Transport for NSW

Sydney Gateway Road Project

Response to submissions report

May 2020

Figure 3.1 Proposed realignment to avoid the Cooks River Intermodal Terminal

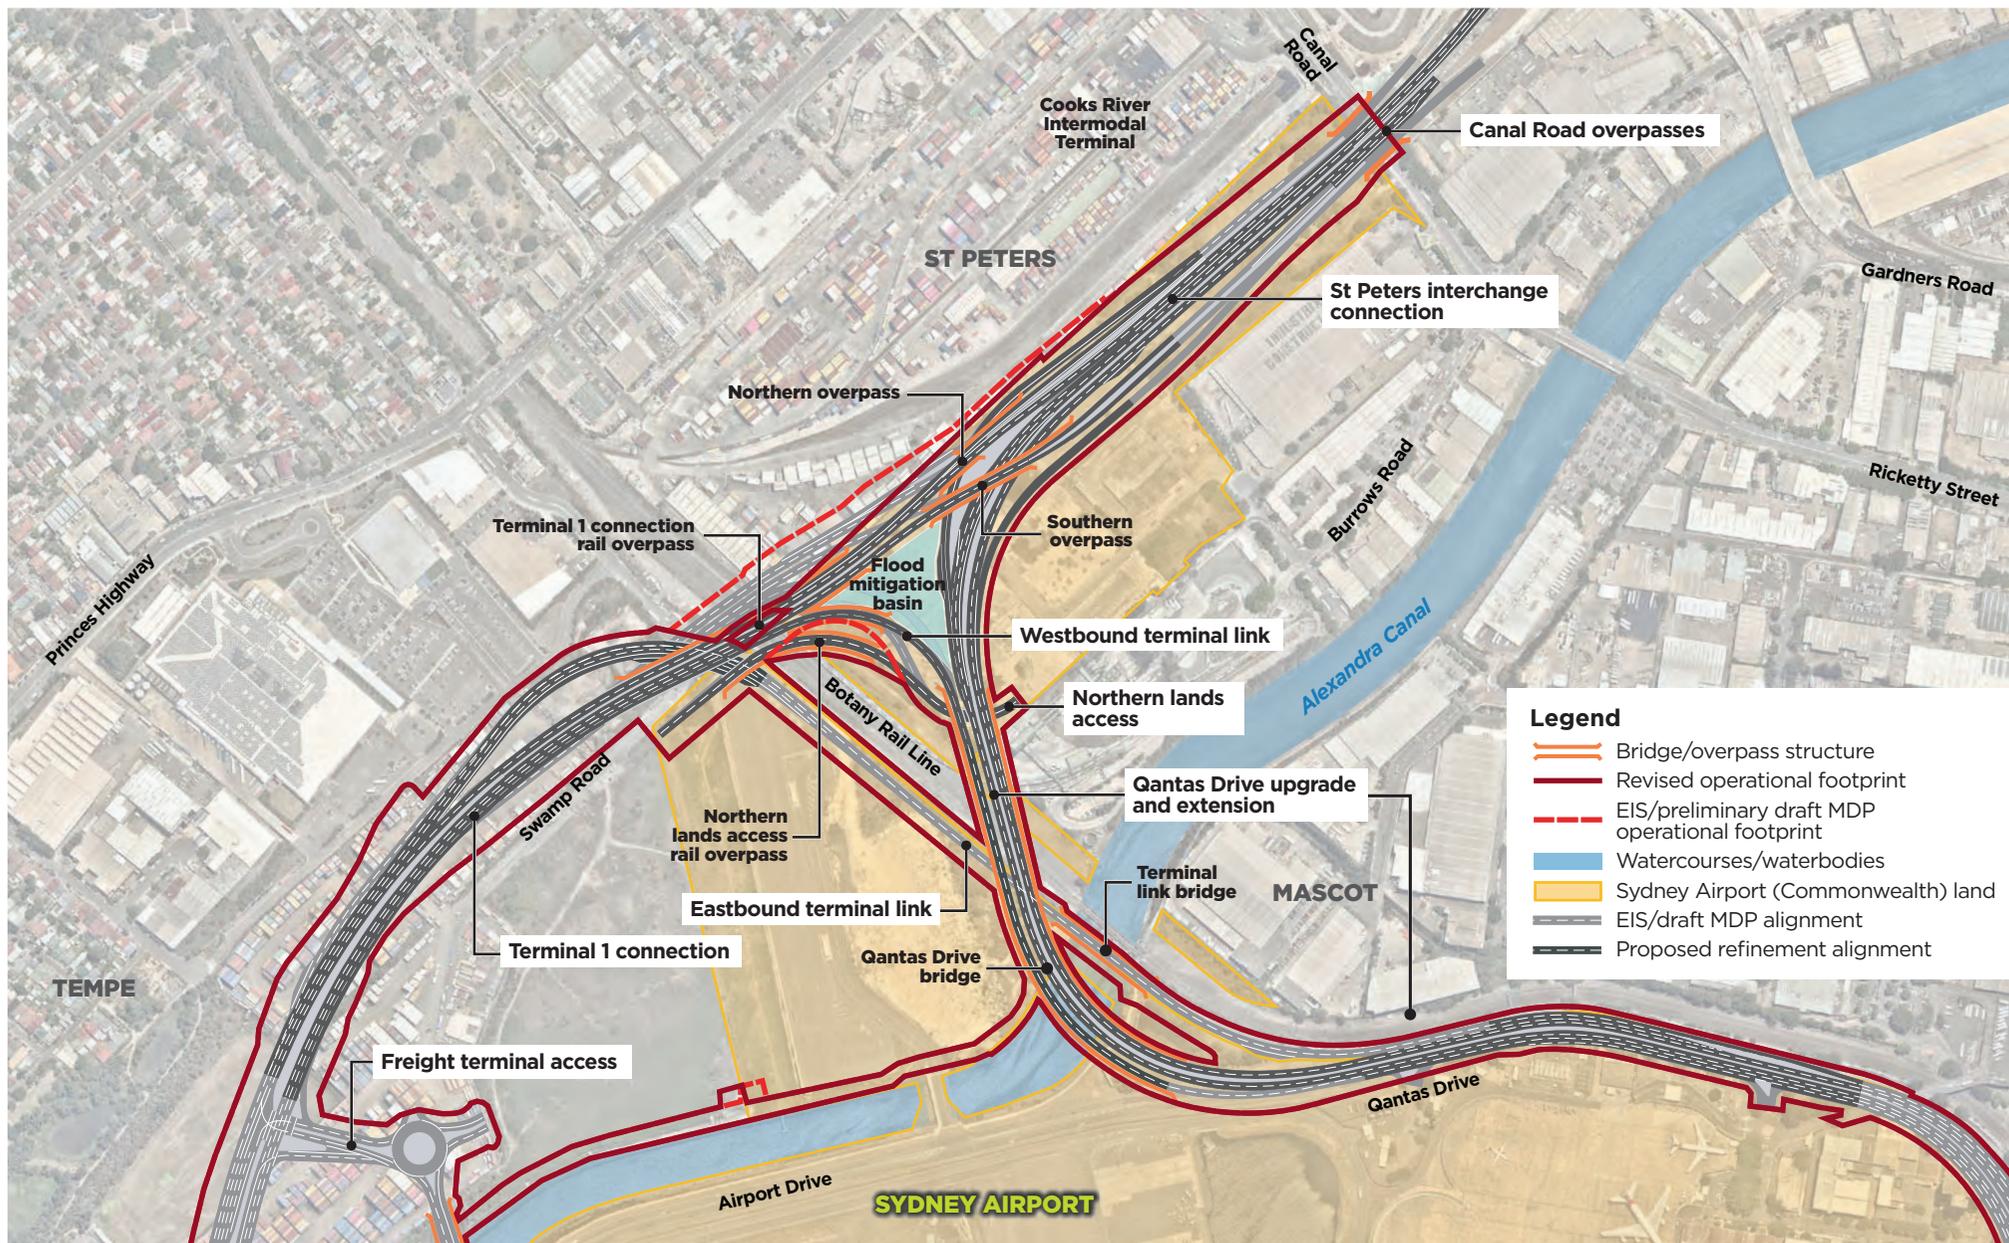
The proposed realignment is shown in Figure 3.1 and Figure 3.2.

The proposed refinement is located on land subject to the EP&A Act and Sydney Airport land (see Figure 3.1 and Figure 3.2).

The proposed refinement would reduce the project's land requirements and the construction and operational footprints. The new footprints are shown on Figure 3.1 and Figure 3.2.

During operation, the proposed refinements are not expected to result in any changes to the impacts outlined in section 11.4.1 of the EIS/preliminary draft MDP. The proposed infrastructure would remain below the airport's airspace. The project refinements, including the relation to the Sydney Airport's obstacle limitation surface are shown in Figure 3.1 and Figure 3.2.

Figure 3.7 Preliminary site accesses and haulage routes

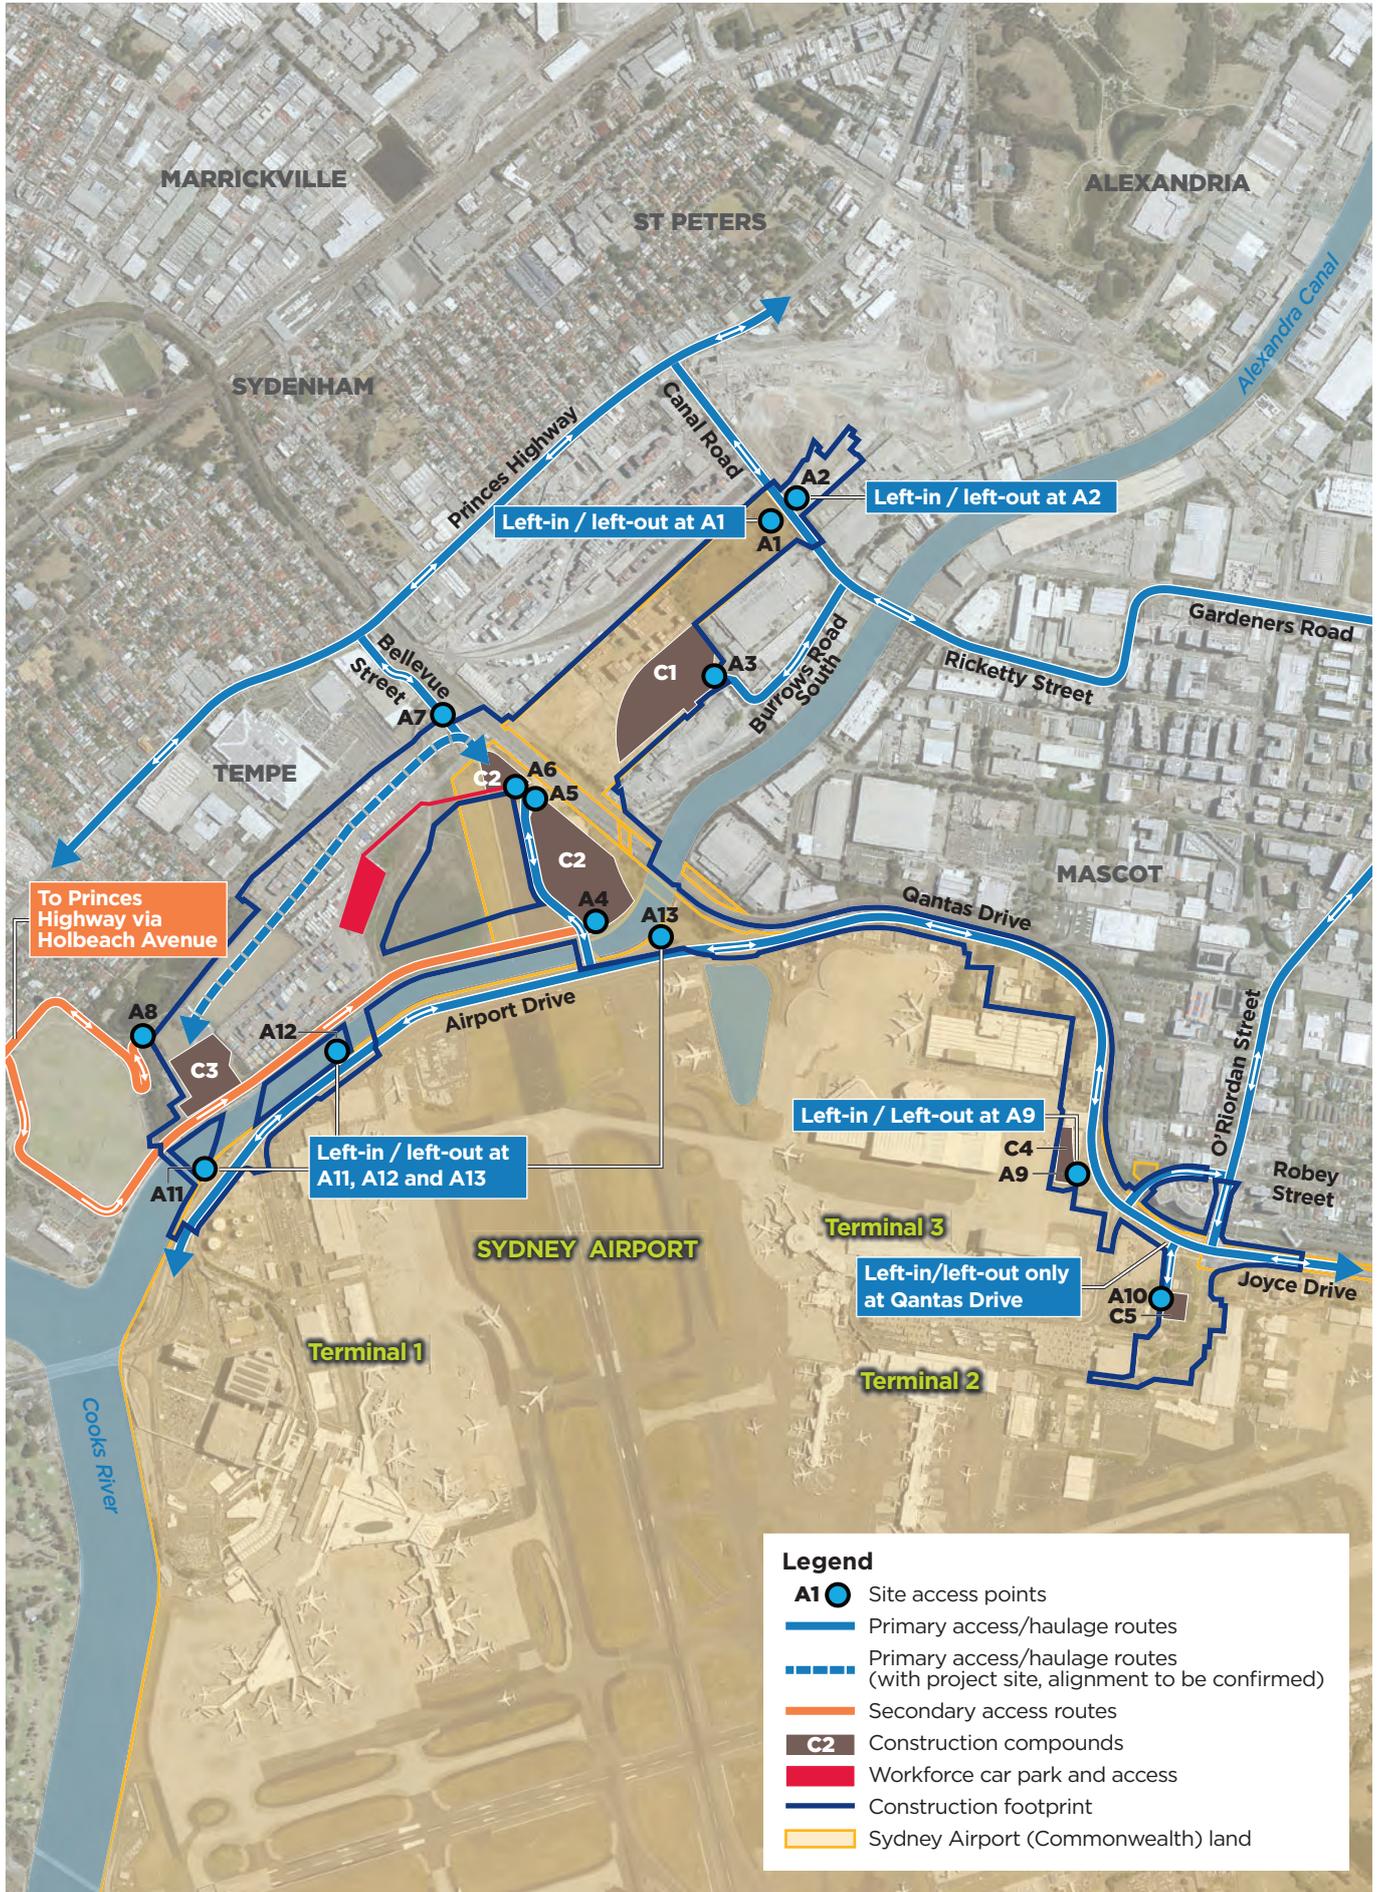
Following submissions from a number of stakeholders regarding the suitability of the proposed haulage routes, indicative traffic volumes and proposed access points, Transport has determined that Holbeach Avenue and access point A8 are no longer required to be used by heavy construction vehicles. Heavy vehicle access to the western bridges compound and work areas would be via access points A4, A5, A6 and A7 (refer to Figure 3.7). Further review of the proposed construction traffic using access point A8 has also resulted in a revision of the estimated light vehicle movements during the peak periods.

Also, as described in section 3.1.2 of this report, the number of truck movements required to transfer landfill waste to off-site disposal locations has increased. Table 3.4 provides the updated construction traffic volumes required for earthworks activities including these two changes (underlined and in bold font).
